**BOARD OF ZONING ADJUSTMENT
STAFF REPORT**

6119/ 6063

5054 OSR, LLC

5070 and 5054 Old Shell Road
(Northeast corner of Old Shell Road and Border Drive North and the West side of Border Drive North, extending to the East side of Parkway East, 220'± North of Old Shell Road.)

SITE PLAN

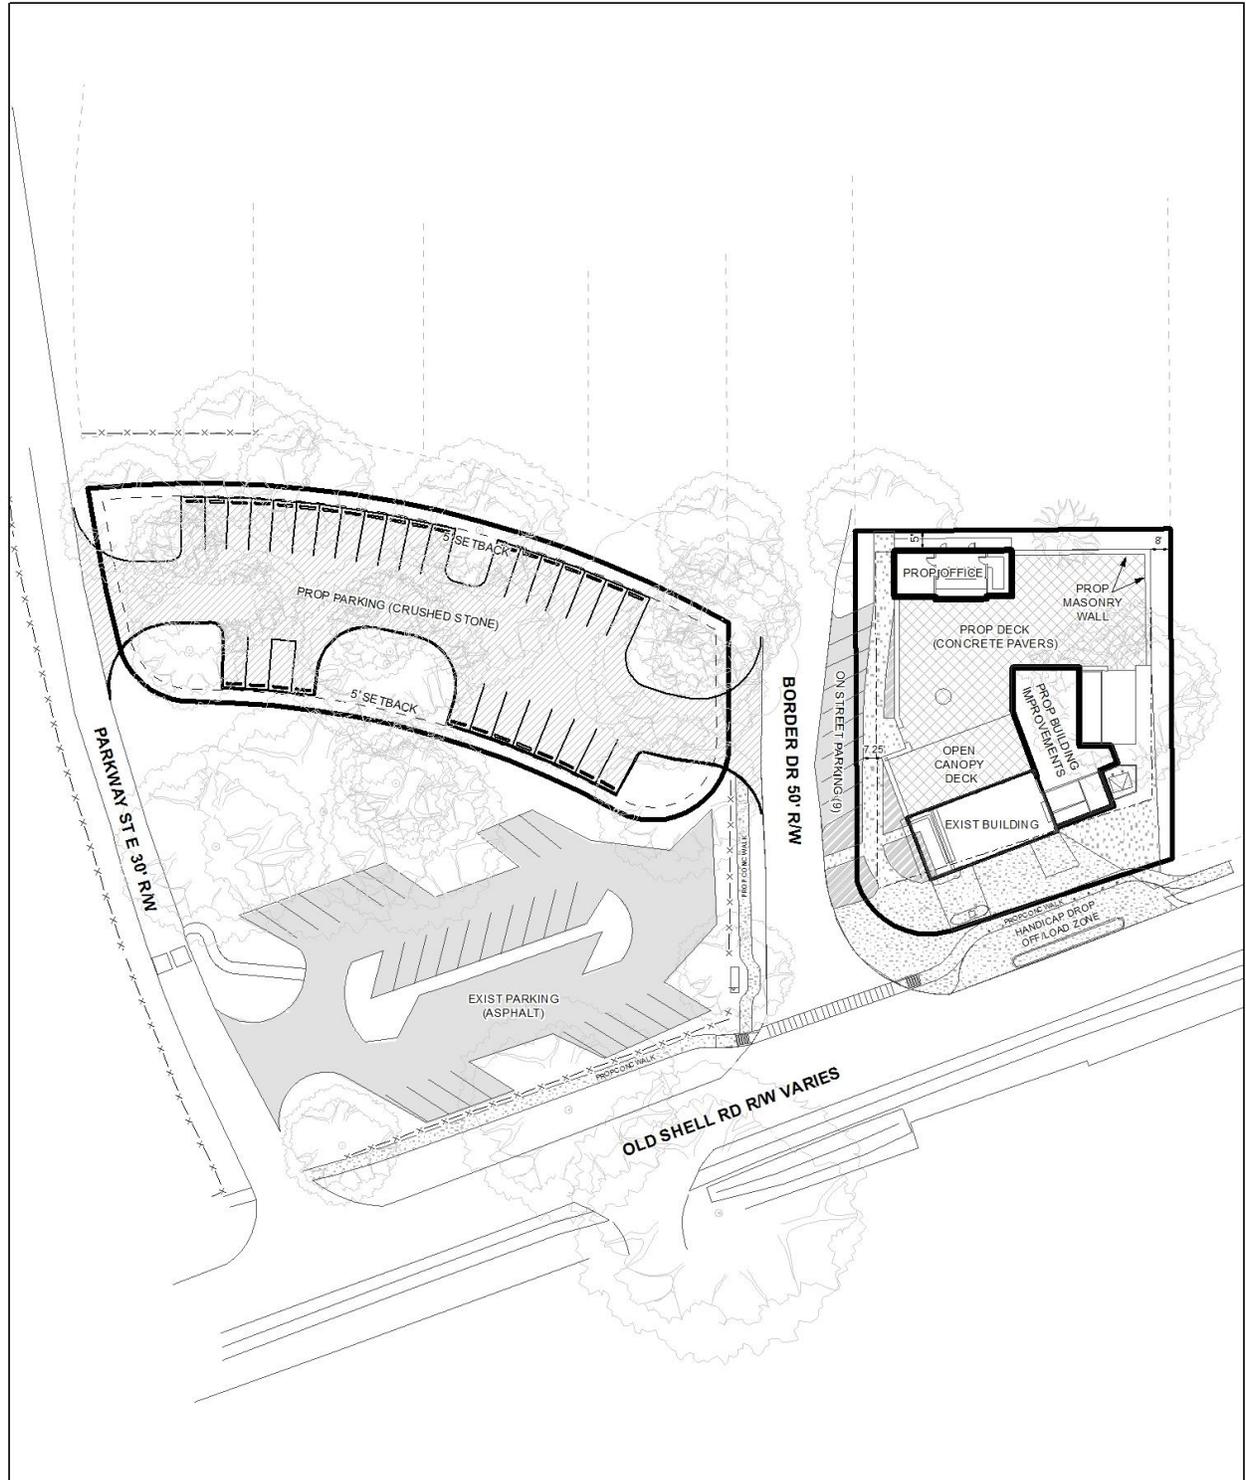
Rester Brothers property. An enhanced landscape buffer will be added on the north side of the proposed parking lot to separate the lot from those neighbors to the north". It should also be pointed out that based on the site plan; the rear yard setback does not appear to meet setback compliance either. When evidence is not provided to support the alleged hardship associated with the property staff can only determine that it is merely the applicant's personal desire not to comply, and not that compliance is unobtainable.

A dumpster is depicted on the site plan (although not clearly identified) however staff is concerned about the location and the accessibility of the dumpster. A statement explaining how the dumpster will be accessed should be included in a revised narrative.

Lastly, almost the entire portion of the site between the building and Old Shell Road is paved with concrete with a continuous curb cut. Per Traffic Engineering, this continuous curb cut should be eliminated, with the site being limited to one curb cut to Border Drive East. The site plan indicates a new sidewalk and crosswalk will be installed along Border Drive East and along Old Shell Road.

- 1) Revised narrative explaining in detail the hardship for the use, side street side yard setback, surfacing, reduced landscape and multiple structure variance request;
- 2) Revised narrative explaining accessibility to the dumpster;
- 3) Revised tree and landscape plan separately depicting the tree planting and landscape calculations for the property with the proposed restaurant and the proposed parking lot;

LANDSCAPE SITE PLAN

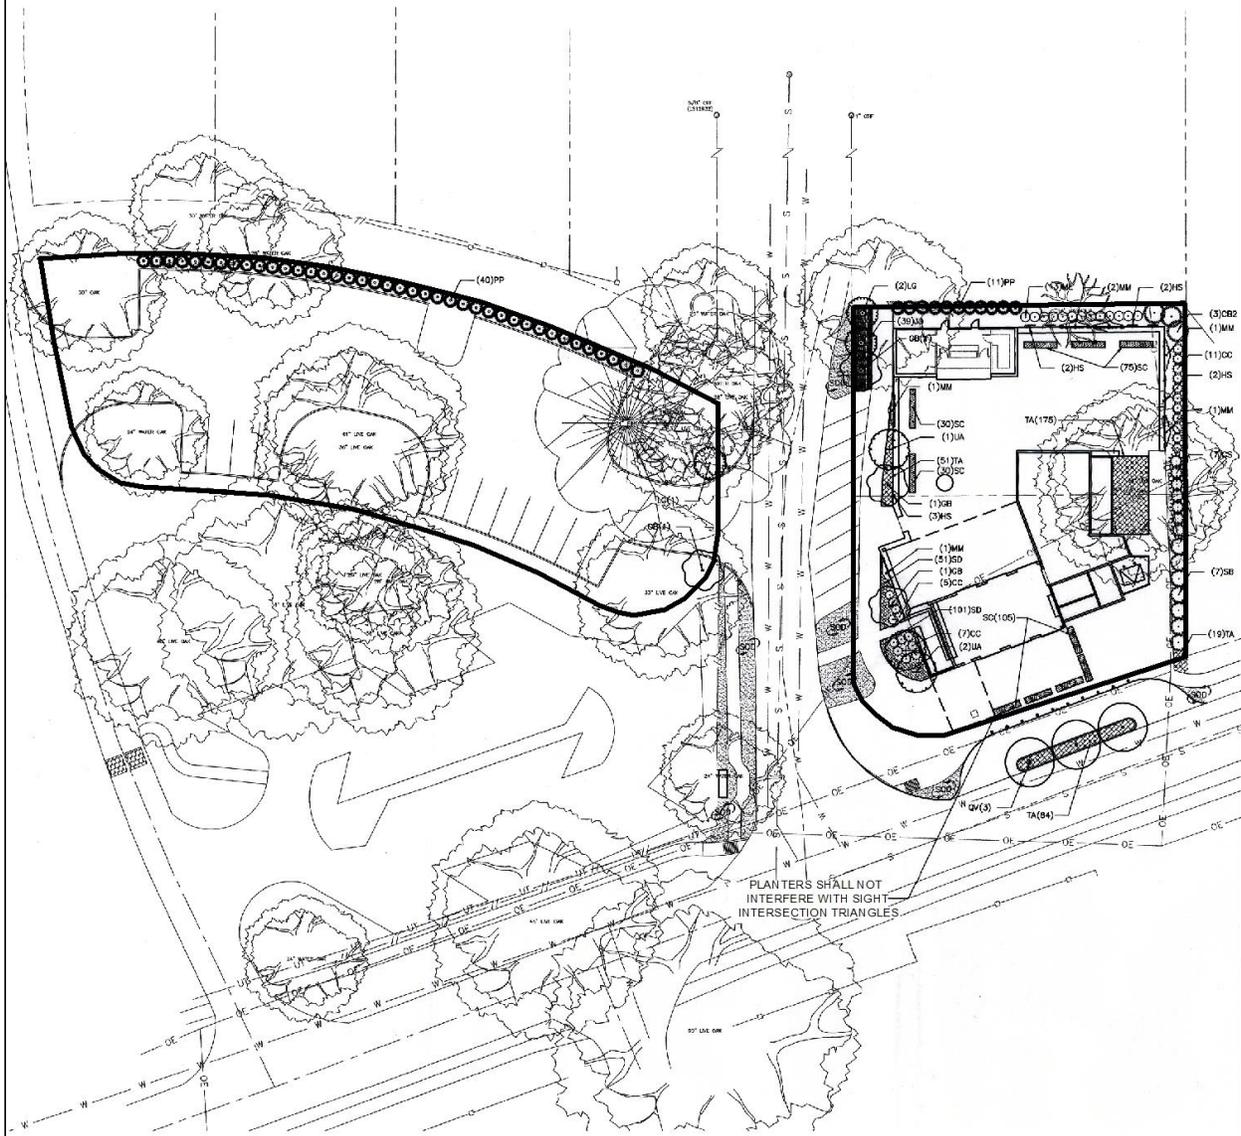
The applicant also requested a reduced landscape area variance because the site as proposed would not be able to provide compliance with front landscape area. Based on the landscape calculations provided by the applicant, the site would in fact be in compliance if the calculations were correct; however staff has determined that there are some discrepancies with the landscape plan. For clarification purposes the tree and landscape plan should be revised to separate and clearly depict the tree and landscape calculations for the restaurant property as well as the calculations for the parking lot. The frontage tree and perimeter tree calculations are incorrect and should be revised. Based on staff's calculations the proposed restaurant property should have 8 frontage trees and 8 perimeter trees. The proposed parking lot property should have 3 frontage trees, 15 perimeter trees, and 3 parking trees (parking tree calculations are subject to change based on outdoor seating square footage calculations). Staff is aware that there are many existing trees on site and applicant may have intentions on using some of the existing trees for credits; however those trees should be specifically identified on the tree and landscape plan. There also appear to be several large heritage trees depicted on a separate site plan that are located on private property that are not shown on the tree and landscape plan. Please note private property tree removal applications will be required for the removal of each tree. Staff also has some concern regarding the placement and close proximity of the 3 live oak trees that are proposed in front of the restaurant property and would recommend spacing the trees to allow more room for each tree to grow.

- 4) Revise the tree and landscape plan to space out the 3 live oak trees in front of the proposed restaurant;
- 5) Revise tree and landscape plan to specifically depict what trees if any will be used for tree credits;
- 6) Revised site plan providing the total square footage calculations for both indoor and outdoor dining is required so staff can determine if adequate parking will be provided; and
- 7) Meeting with the neighborhood to discuss possible traffic concerns.
